Technical Service Bulletin

Subject: BOTTLE TILTING ISSUE IN REAR SEAT CUP HOLDER (6-PASSENGER CENTER WALK-THROUGH VEHICLE)	Bulletin No.: 09-044/25
	Last Issued : 12/01/2025

2024-2026 CX-90 with VINS lower than JM3KK*****354521 (produced before September 16, 2025)

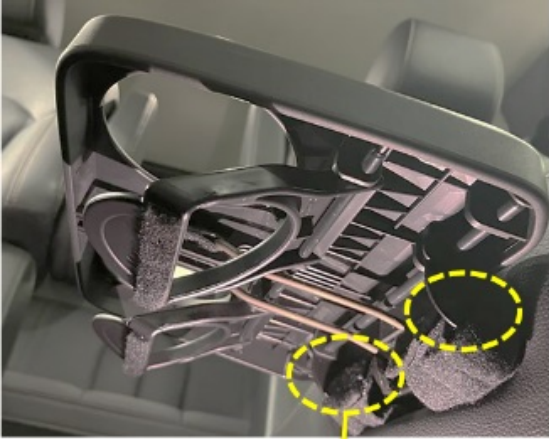
Some customers may experience a bottle tilts to the left when using the second-row cup holder in 6-passenger center walk-through vehicle. This is caused by a combination of dimensional defects in multiple components. To eliminate this concern the component dimensions have been modified to ensure the cup remains level.

NOTE: The cup holder is secured with nuts (non-reusable parts) located within the dotted circle. The specified tightening torque is 19 in-lbf (2 Nm, 21 kgf-cm).

1. Verify the customer concern.
2. Replace the cup holder.
